# Product Change Notification

<b>Change Title</b>	M.2 4TG2-P/4TS2-P PCB Change Notice	<b>Date</b>	2023/02/13	<b>PCN No</b>	F2306
<b>PCN level:</b>	Minor				
<b>Models:</b>	M.2 (P80) 4TG2-P/4TS2-P, M.2 (P110) 4TG2-P				
<b>Category:</b>	Hardware - PCB

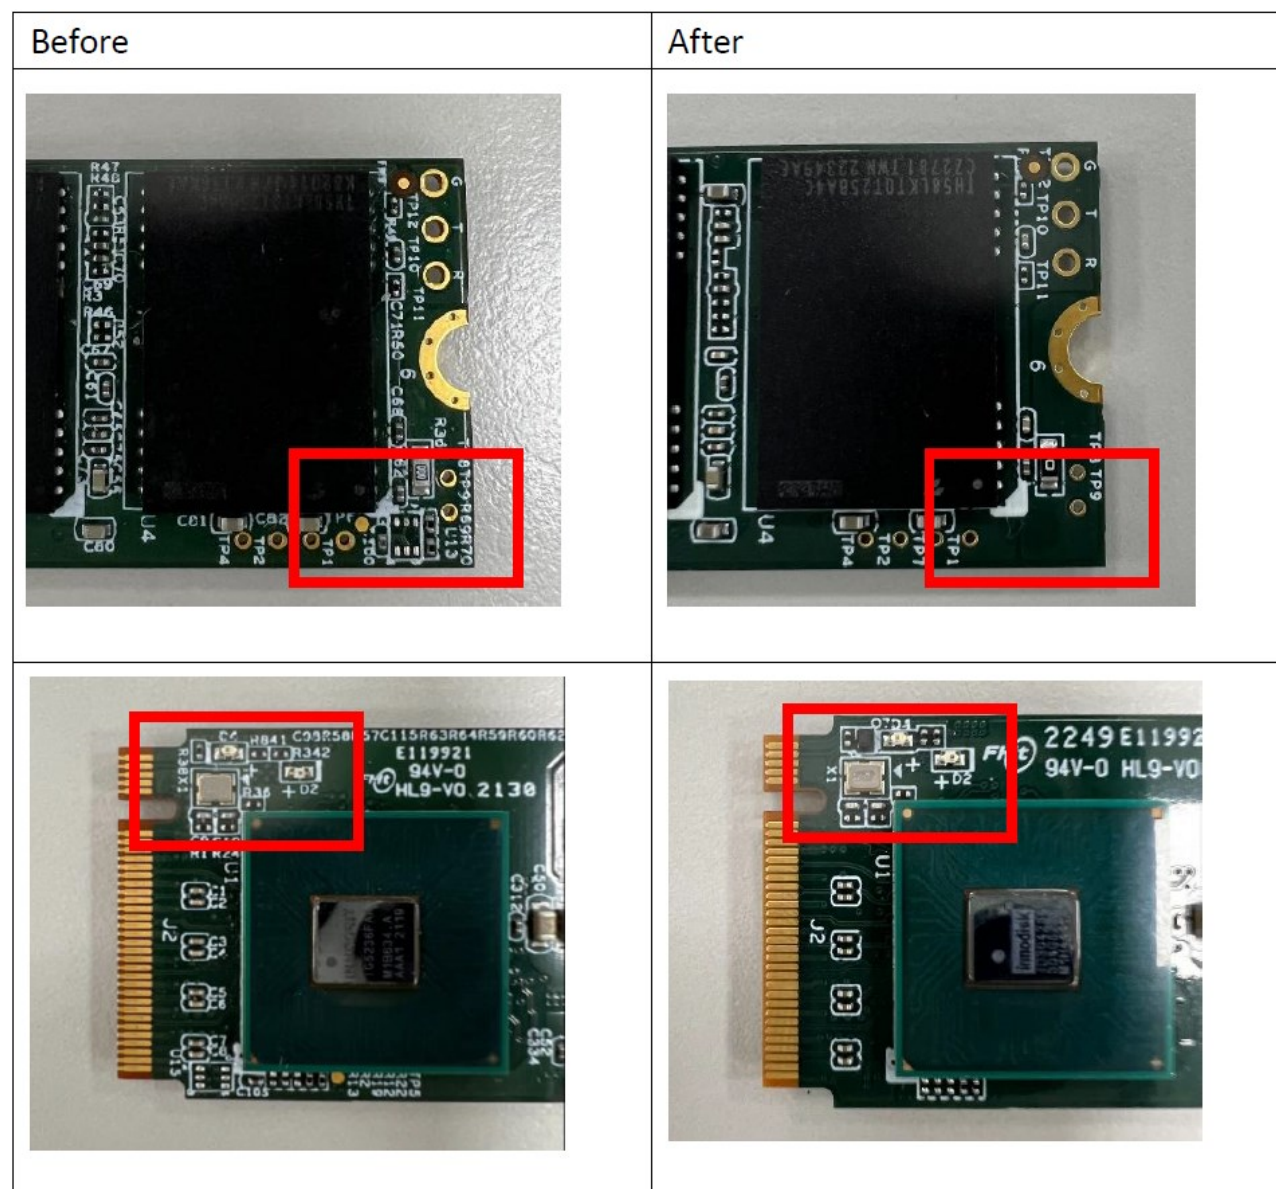
Minor change: modify circuit design of LED\_Access on device for compatibility. The rest of layout design has no change.

Before: LED\_Access on device and LED(DAS) from Pin10 signal status are opposite when device idle.

After: LED\_Access on device and LED(DAS) from Pin10 signal status are the same when device idle.

The following pictures shows detailed differences on PCB.
